Bulletin No.: SB090710 Release Date: 09/07/2010 Effective Date: 09/07/2010

SAFETY ALERT

RIDE NAME: Vertigo

ABSTRACT OF ISSUE: Improper Perimeter Fence Set Up / Shape

DETAIL OF ISSUE: Page 3 of 5 Vertigo 100 Illustration PASSENGER REQUIREMENTS MINIMUM HEIGHT MAX PASSENGERS MAX PASSENGERS MAX TOTAL PER TWO-DOSITION SEAT MAX TOTAL PER TWO-DOSITION SEAT MAX TOTAL PASSENGER LOAD MAX LOAD IMBALANCE TOWER/WING BOLT TORQUE HEIGHT

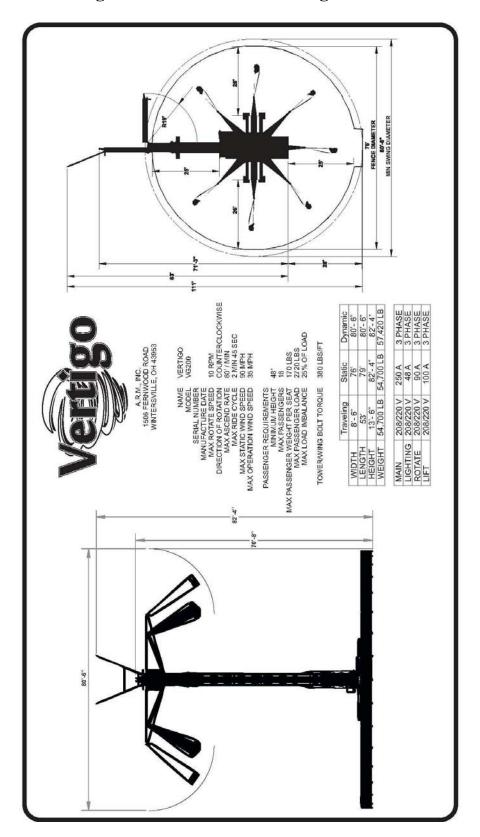
As an added safety measure, 6 additional perimeter fence sections are being added to increase the perimeter diameter to 76/ft. The number or fence panels shall increase from 28/pcs to 34 pcs. These additional sections will allow for a larger margin of error in set up due to issues such as, Set up error, and Daily inspection error and or uneven terrain.

Replacement of the existing ride information tag is necessary. New ride information tags are being printed and must be installed once received. Until this time, the illustrations provided on the following pages of this bulletin must be used.
